1 1/4" PRESSURE REGULATOR SETUP

UPDATED AS OF MAY 2018

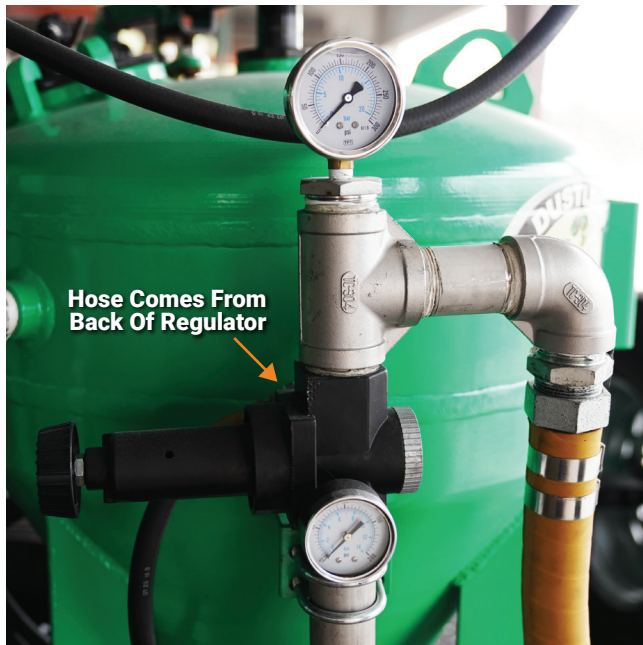
DB500™ and DB800™ machines built prior to May 2018 may have an outdated regulator setup. To check if your 1 1/4" Pressure Regulator is outdated, look on the backside of the regulator and confirm if there are two ports, one of which is used for a hose. If your regulator matches this description, you will need to update your regulator when it is time to replace it.

Updating your pressure regulator to the newest setup is a fairly simple process that only requires one new component in addition to your new 1 1/4" Pressure Regulator, which no longer has two ports on the back.

In addition to your regulator, your new setup will also require a "Male Female Run T". Install your 1 1/4" Pressure Regulator as you normally would. The hose that was connected to it will now be connected to Run T that you will install.

The Run T can be installed by removing the liquid filled pressure gauge and installing the Run T in its place. Once that is done, you can reconnect the liquid filled pressure gauge to the Run T, as well as the hose that connects to the 1/4" filter regulator on the control box. Once those are all connected, you are fully updated and back in business!
